**COMMENTS ON EPA RFS2
PREAMBLE AND
DRAFT REGULATORY IMPACT ANALYSIS**

Prepared For:

National Biodiesel Board
605 Clark Avenue
Jefferson City, MO 65110-4898

Date: May 27, 2009

Figure 2-1 Change in Energy Consumption

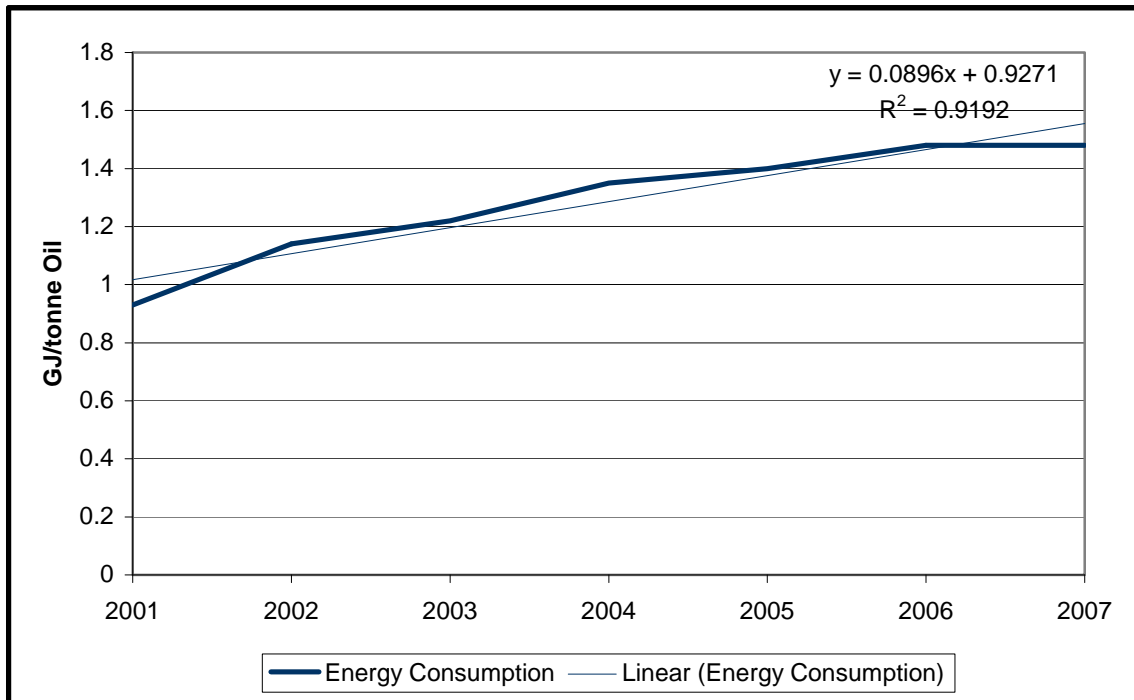
What is more concerning, however, is that the OGP data indicates a very significant trend in the energy used for crude oil production. The energy used in oil production is a function of the depth of the reservoirs, their internal pressure, the amount of co-produced water and other factors. It is known that as reservoirs age the energy required to produce the oil increases. Data from OGP is available for the years 2001 to 2007 and the average energy requirements are shown in the following figure. This figure could be influenced by different participation rates and different companies participating but other than the Americas the participation rates have been steady through the time period.

Extrapolating the trend through to 2022 would indicate that the energy requirements could increase from the 1.40 GJ/tonne in 2005 to 2.70 in 2022. This would increase the baseline emissions by approximately a further 2,500 g/mm BTU.

Figure 3-1 International Soybean Yields

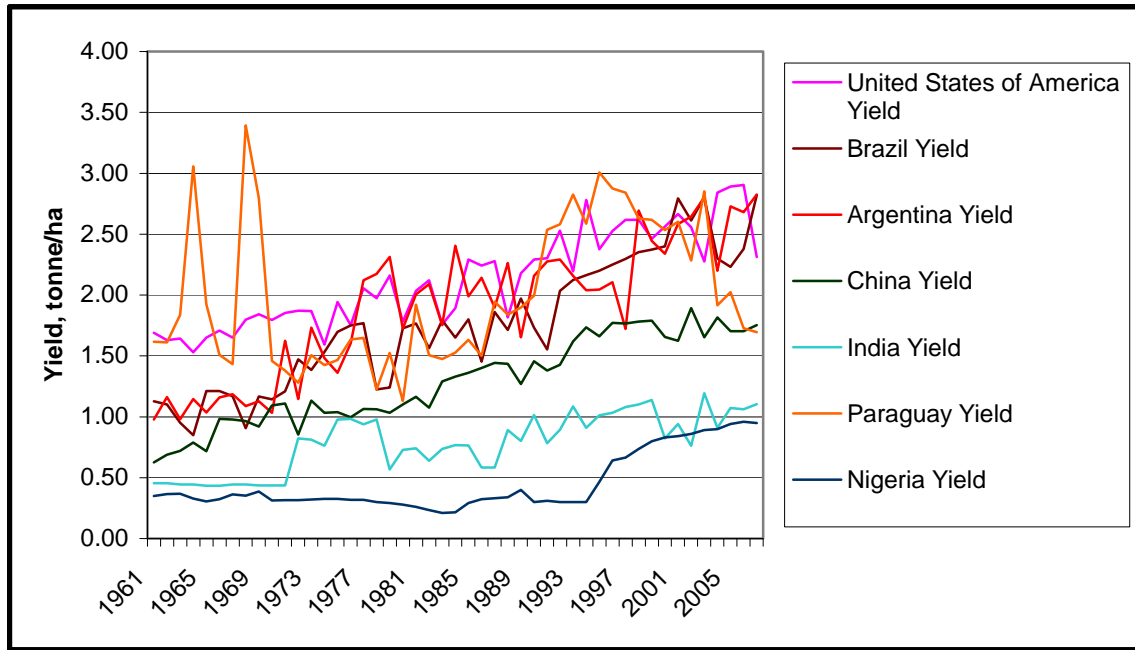
The only information on yield that is presented in the DRIA is for Argentina and Brazil and the expected soybean yield in 2022 is 48 to 50 bu/acre. There is little information on the yields in the other countries that are expected to see area changes. The FAO data on soybean yields in the major countries identified by the EPA are shown in the following figure.

It can be seen that yields in Nigeria, India, and China are well below the yields in the other countries and this will increase the quantity of land that must be converted to produce the required crop. There can be a number of reasons for the low yields but nutrient application, varieties planted and management practices can be addressed in short periods of time. India and China, for example do not use genetically modified soybean seeds and that has a detrimental impact on yield, China imports GM soybeans and India produces GM cotton so it is not unreasonable to consider that they could decide to produce GM soybeans before 2022 and thus have a significant impact on the world supply and demand and the estimated indirect land use change which is being attributed to soybean biodiesel.

Figure 6-1 US Soyoil Production and Demand

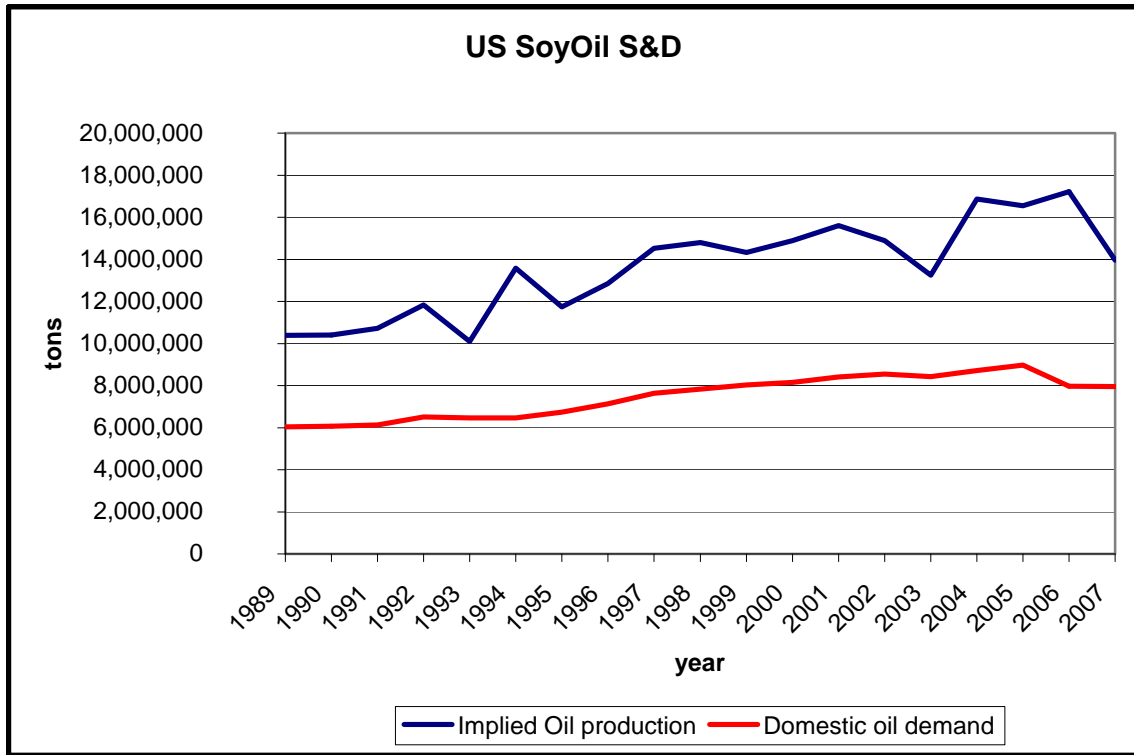
Perhaps the more troubling issue with respect to the reference case is the indirect land use emission baseline. This is established as a 2022 business as usual scenario. So the combined reference system for biofuels is actually the direct emissions for a petroleum diesel fuel baseline with data from the 1990's and a projected 2022 land use scenario for calculating the indirect land use emissions. Improvements in agricultural productivity between 2005 and 2022 are essentially ignored (or credited to exports). The only role that agricultural productivity has in the 2022 land use calculations is the quantity of land required to meet the extra demand in 2022.

The 2022 business as usual baseline produces 19% more soybeans than were produced in 2005. There is no information presented in the documentation that shows what this increased production is used for. The domestic demand for soybean oil (and meal) has not been increasing at the same rate as production in the recent past as shown in the following figure. Since 1989 production is up about 50% but domestic oil demand is up only about 30%.

Figure 6-2 Short Term Soyoil Demand

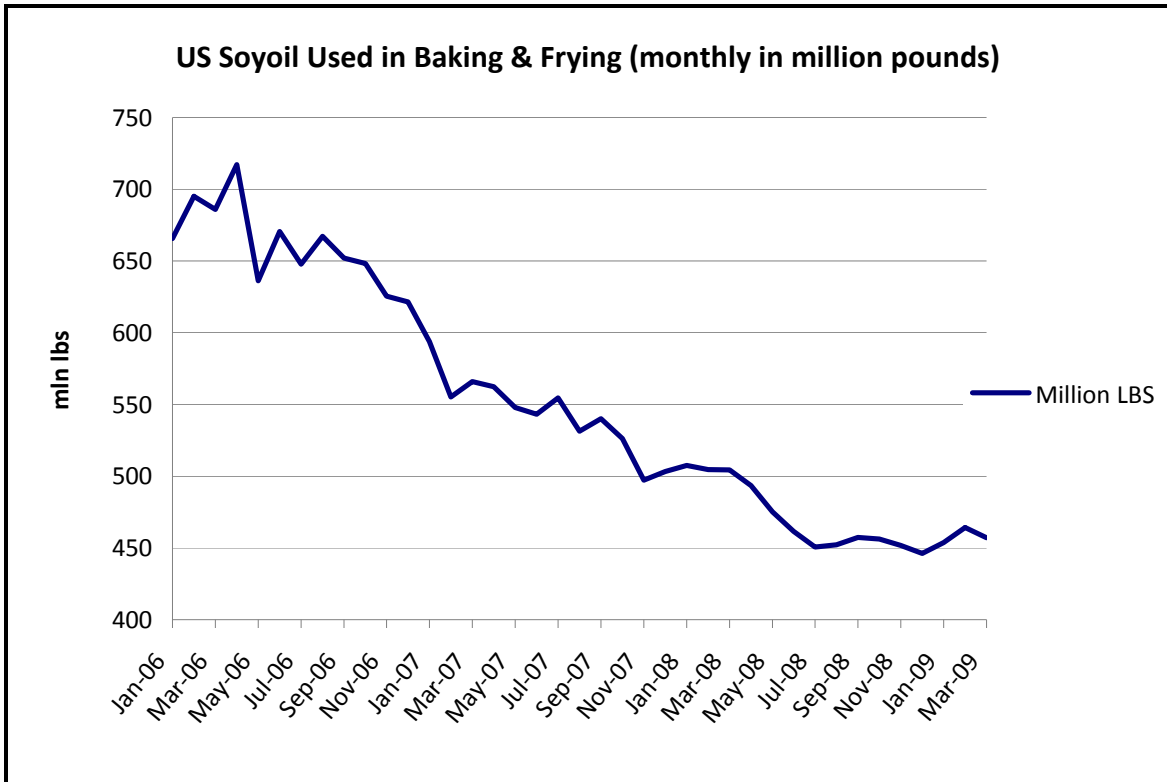
The short term trend in soyoil demand for food purposes (US Census Bureau) is shown in the following figure. This more dramatically shows the impact of recent demand changes. This type of non-biofuel demand change cannot be accommodated in the land use modelling done by the EPA and this is a clear shortcoming in the approach.
